OCONEE NUCLEAR STATION

PROPOSED TECHNICAL SPECIFICATION REVISION

October 26, 1977

FIGURE 3.5.2-6A1

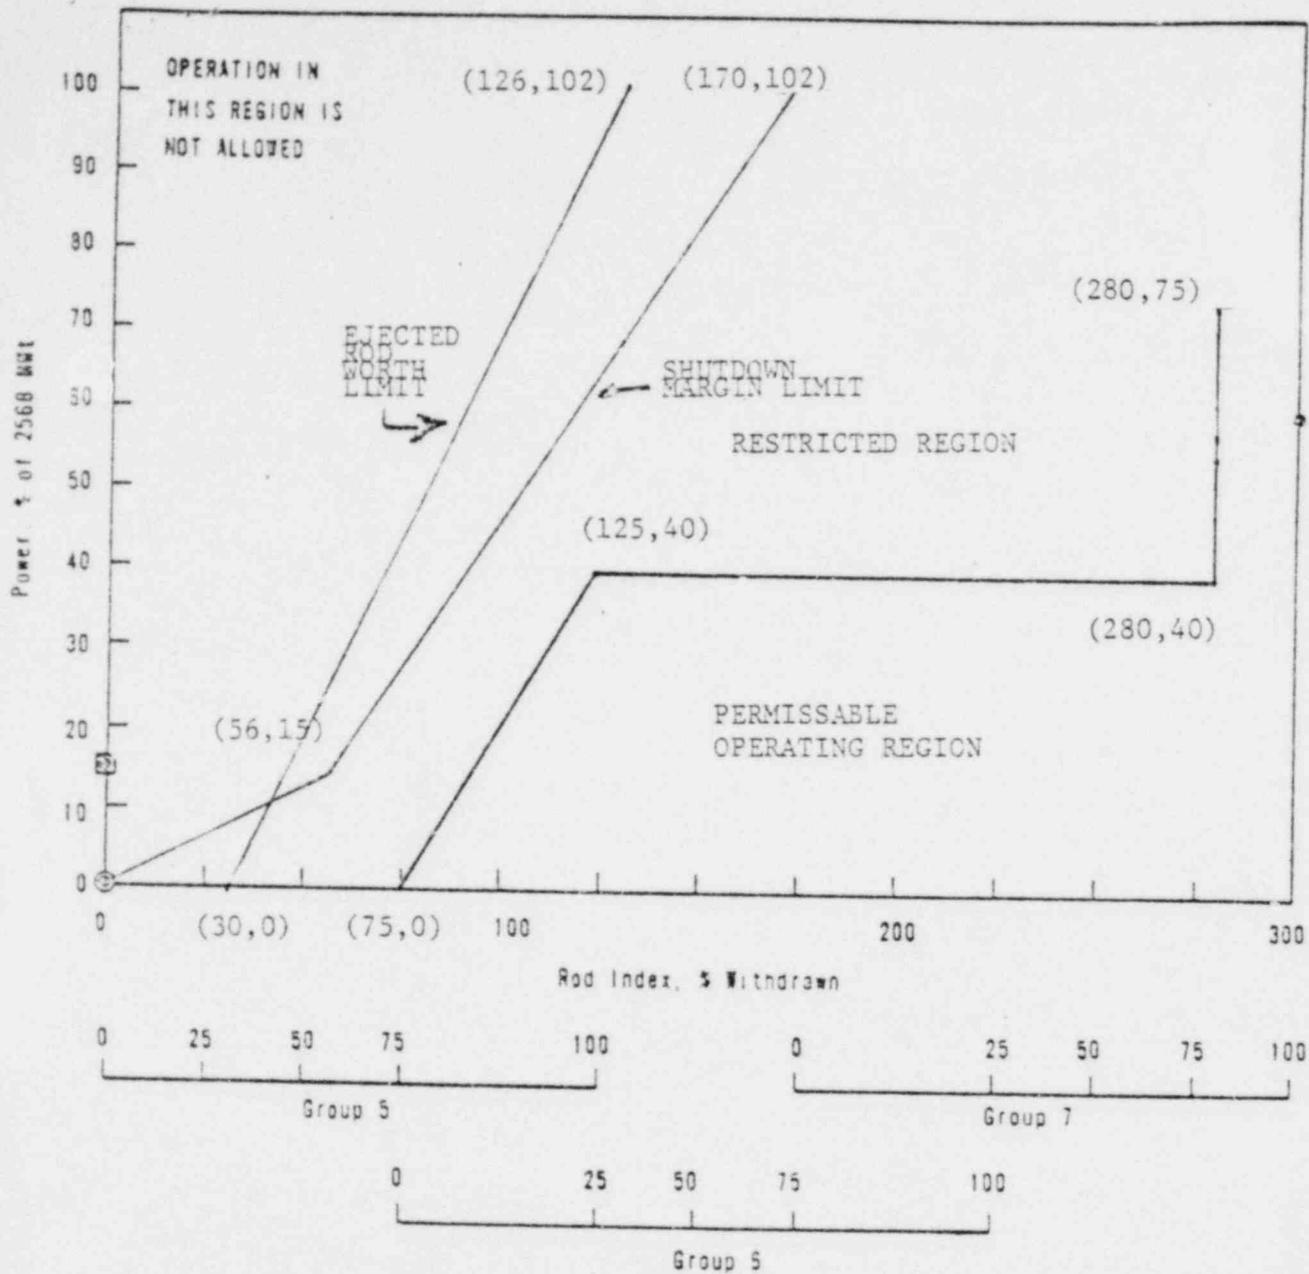
3.5.2.8 For Oconee Unit 1, in the event Specifications 3.5.2.4.a or 3.5.2.5.c are not met, operation shall be restricted as follows:

- a. The core thermal power shall be limited to 75 percent full power.
- b. The nuclear power maximum setpoint shall be 84 percent full power.
- c. The quadrant tilt shall not exceed 6.03 percent.
- d. The regulating control rod insertion/withdrawal limits are specified on Figure 3.5.2-6A1

If any of the above provisions are not met within two hours, the reactor shall be in the hot shutdown condition within an additional 4 hours.
